**Re: HUESTAS DE LA FE Church Expansion  
Grading and Drainage Plan  
Engineer's Stamp date 4-15-12 (G-15/D104)**

**Re: HUESTAS DE LA FE Church Expansion**  
**Grading and Drainage Plan**  
**Engineer's Stamp date 8-10-11 (G-15/D104)**

**RE: Grading and Drainage Plan  
Huestas de la fe  
G15/D104**

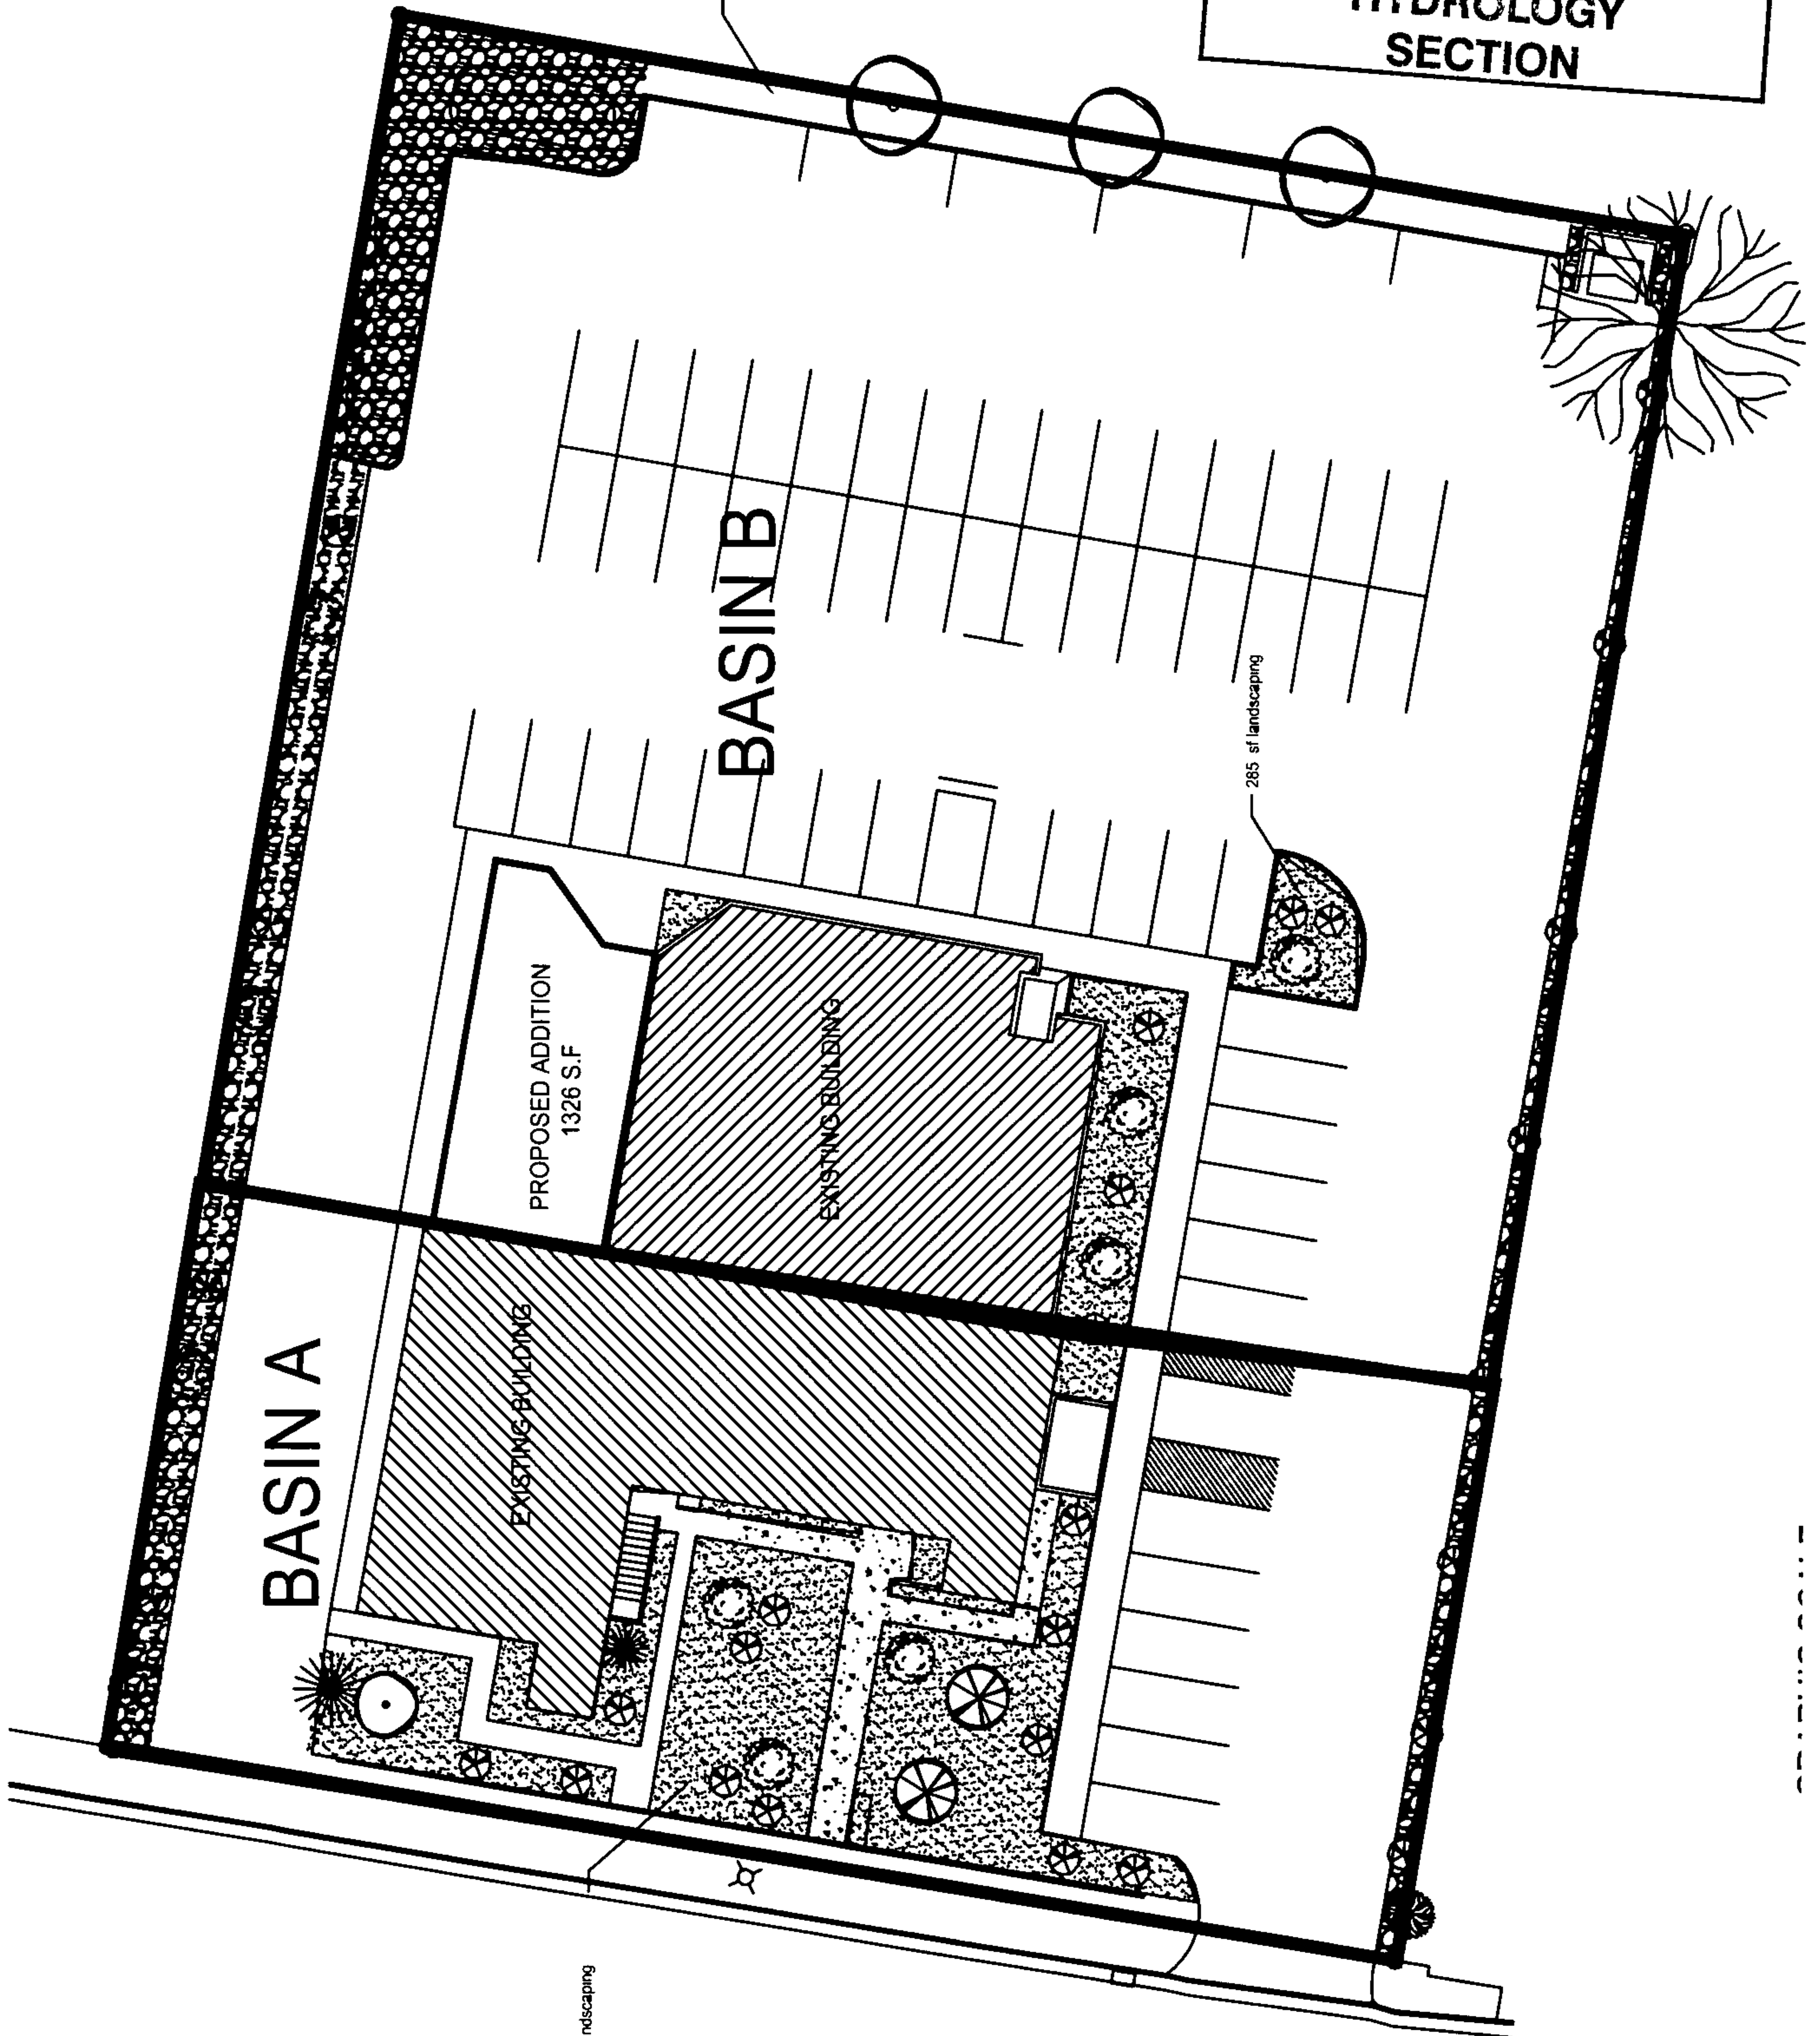
- Show the AH flood zone at the west end of this site on the plan. *FL-71*
- Is this addition being placed over existing concrete? If so, what does keyed not 4 pertain to? *Remove*

- It is difficult to confirm your land treatment calculations for this site please adjust your plan accordingly. *Exhibit*
- Give elevation points from the surrounding sites. ✓

- Prior to CO, an Elevation Certificate for the existing structure in the AE Flood Zone is required. ✓
- A Floodplain Development Permit is required for the proposed building in the AE Flood Zone. *Not in Flood Zone*

- Provide routing calculations for the pond to verify maximum discharge and the 100 year WSEL. *NA*
- Remove all notes pertaining to the French drain. ✓

- Is this site being repaved or is it being repaired? Are the Islands providing landscaping or are they just painted? *Repair (Pave) as shown.*
- It appears that the water blocks are in the wrong locations, does this change your calculations? ✓

- At the area drain location, what is the land treatment for this area? It does not appear to provide any slope toward the inlet. *Remove*
- Call out flowline elevations at the Northern entrance on 2<sup>nd</sup> St. ✓

Hydrology is requesting that proposed landscape areas be depressed to retain/infiltrate the rain that falls on them. ✓

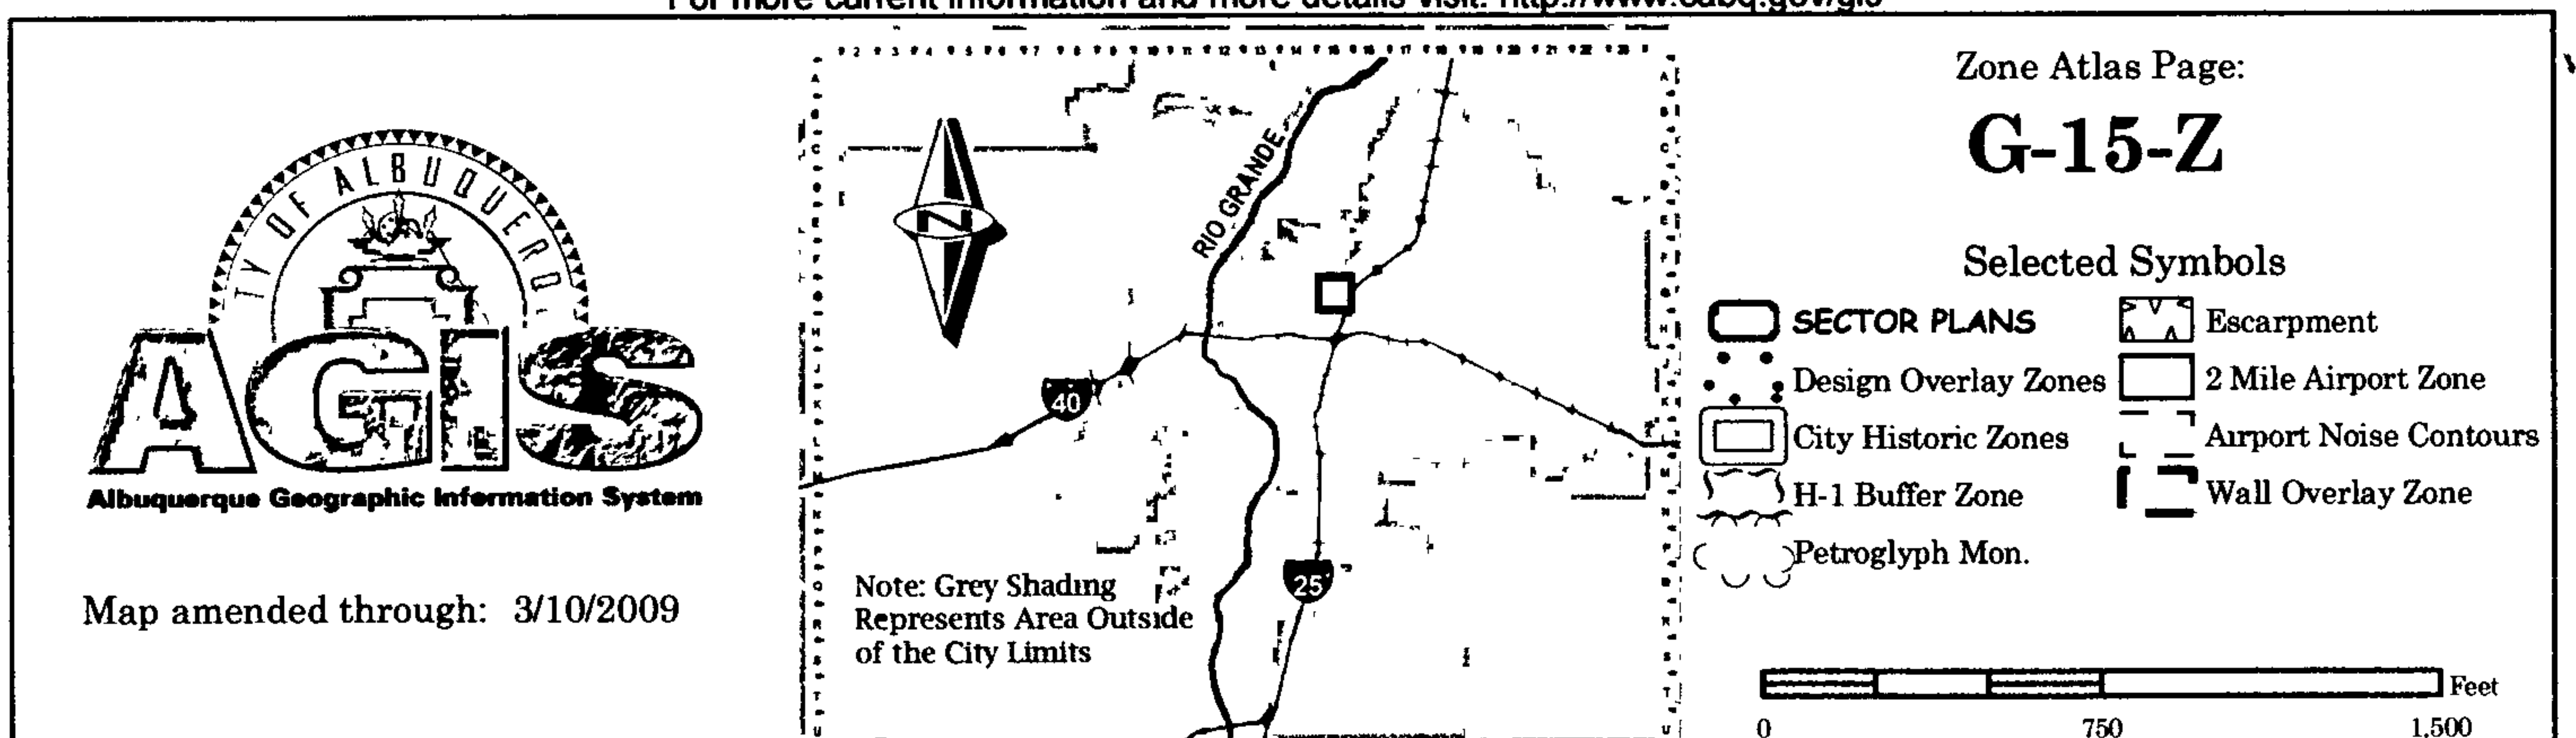
Clarify exist vs proposed

Parking Calcs

Call out width of all curb cuts

Details for ~~driveways~~ - too close together,  
suggest a flat landing along  
all h.c. spaces - bumpers along  
spaces

Wood  
Fencing, Landscaped strip - located  
within driving aisles, must be removed
